## **BID ADDENDUM NO. #2**

June 8, 2022  
Town of Campbell  
Water District #1, Extension #1  
HUNT 1313-021

The following Addendum items shall be considered a part of the contract documents prepared by HUNT ENGINEERS, ARCHITECTS, LAND SURVEYORS & LANDSCAPE ARCHITECT, DPC. Bid Document date of April 2022.

**1** GAS PIPE TRENCH DETAIL  
SCALE: N.T.S.

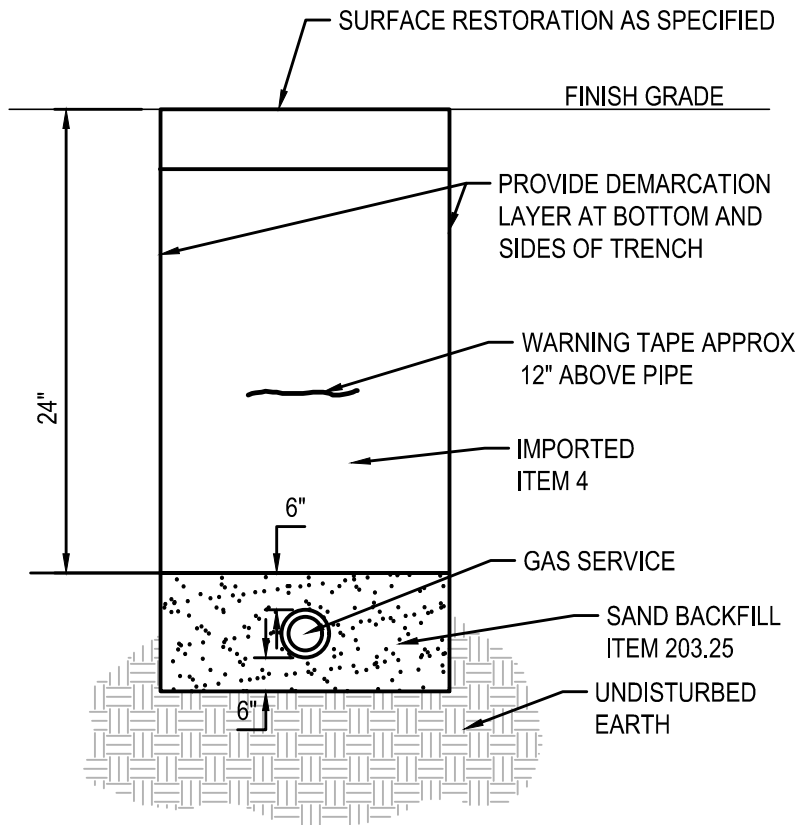
18. The excavation and backfill of the gas line is the responsibility of the G.C. in Contract #2. The detail for installation has been provided within this addendum.

**ADD** Drawing AD-1 Natural Gas Detail – Contract #2 in its entirety.
